September 21, 2016

Subject: 2014 North Cirby Way, and 1202 & 1204 Samoa Way– Infill PCL 315 – Champion Oaks Rezone and General Plan Amendment Pre-Application– PL16-0263

CITY OF ROSEVILLE
PLANNING DEPARTMENT STAFF REPORT
PLANNING COMMISSION MEETING FEBRUARY 9, 2006
 Prepared by: Wendy W. Hartman, Project Planner

ITEM V-A: GENERAL PLAN AMENDMENT, REZONE, GRADING PLAN & TREE PERMIT – 2009 N CIRBY WAY (PRIMARY APPLICATION ADDRESS) – DE MELLO REZONE – FILE #S: GPA 02-08, RZ 02-04, GP 03-19, & TP 03-30.

REZONE EXHIBIT for SUNSET WEST EXECUTIVE COMMUNITIES

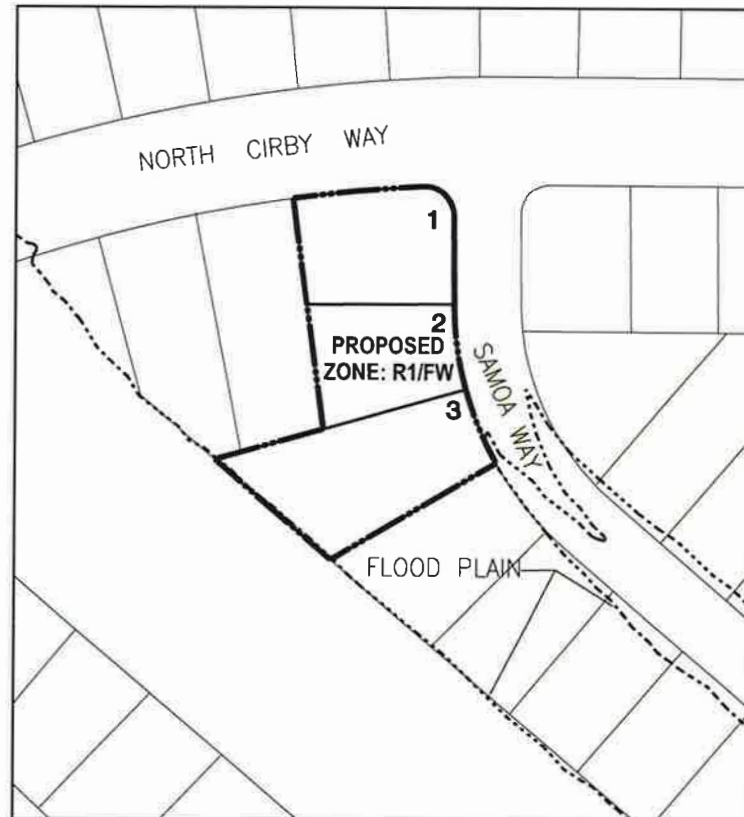
In review of the proposed project (Attachment 3, Rezone Exhibit) the City has identified the following:

- The proposal is inconsistent with the City's General Plan Policies:
- The proposal is locating residential housing in an area that has a documented history of flooding;
- The introduction of residential housing in an area designated as a flood hazard area and designated Floodway Zone district is inconsistent with the City's Zoning Ordinance;
- Past City actions by the Planning Commission has not supported modification of the General Plan or Zoning for properties in this area; and,
- The introduction of additional residential uses in flood prone areas does not support the health, safety or welfare of the existing and potential future residents of Roseville.

It is for these reasons that the City cannot support this project proposal. Although it is not supported as a viable development proposal, you have every right to submit a formal application to amend the General Plan land use and rezone the property.
